**ON-SITE SEWAGE DISPOSAL SYSTEM
 HOWARD COUNTY HEALTH DEPARTMENT
 BUREAU OF ENVIRONMENTAL HEALTH**

SUBDIVISION: The Chase LOT NUMBER: 15

ADDRESS: 11637 Masters Run PROPERTY OWNER: Thomas M. Moran

P522087

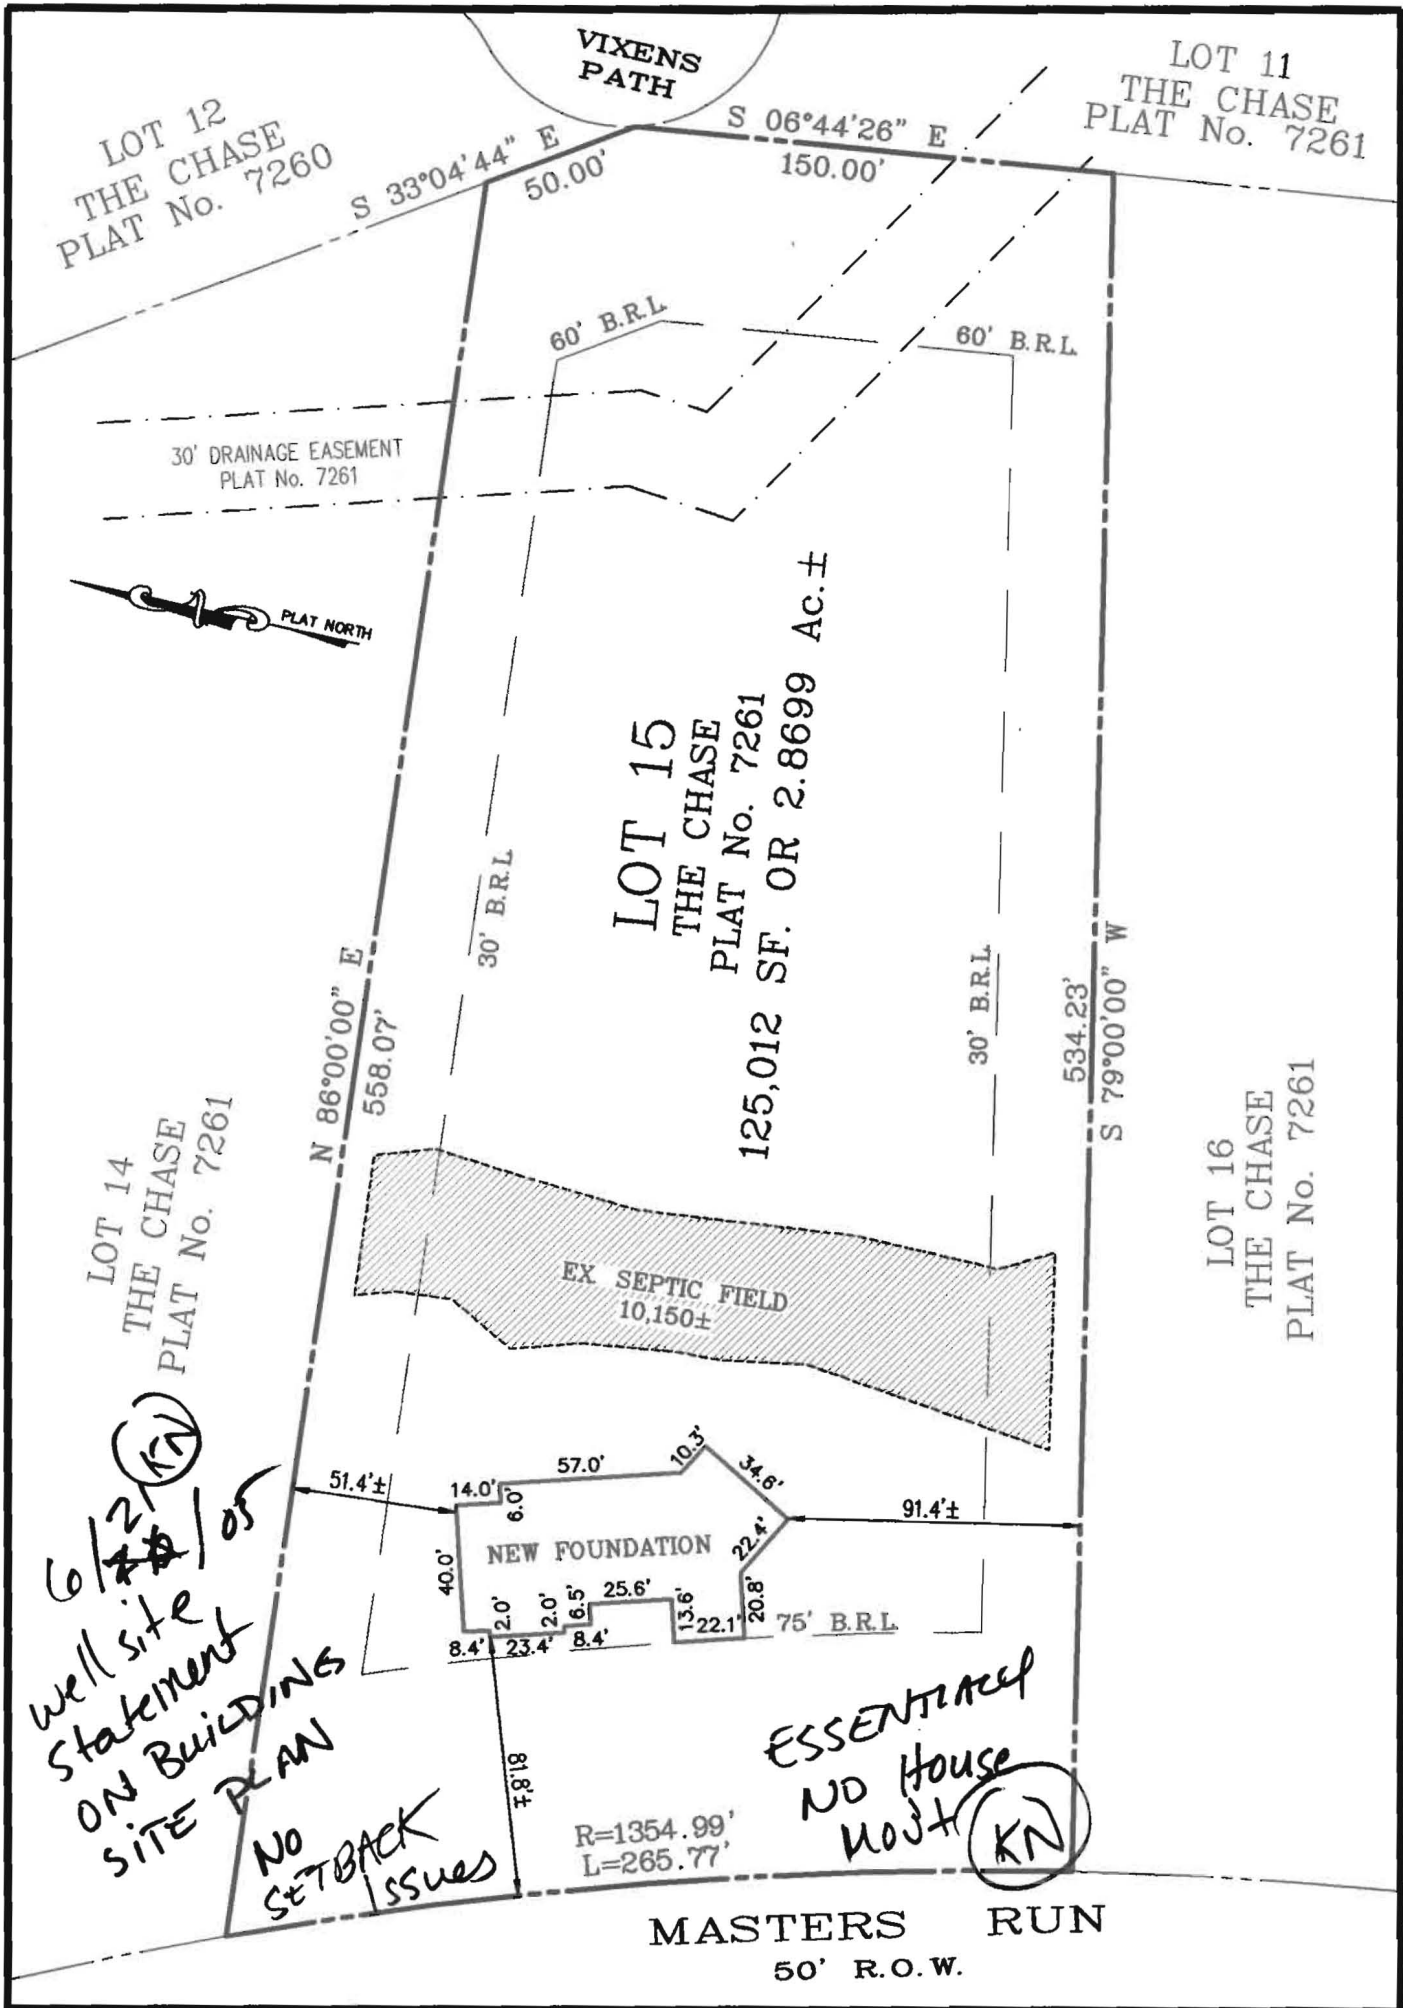
PRE-CONSTRUCTION 6/30/05 To install trenches as they are located on the B.P. plan. Keep everything as shallow as possible

INSTALLATION with minimum fall so that any repairs on the opposite side of the easement will be as shallow as possible. Stay out of the swale. (BB) 7/6/05 Final, OK to cover. Trenches slightly off contour at ends ^(2-3') but inlet deep enough to account for this. should not be a problem. (GAC)
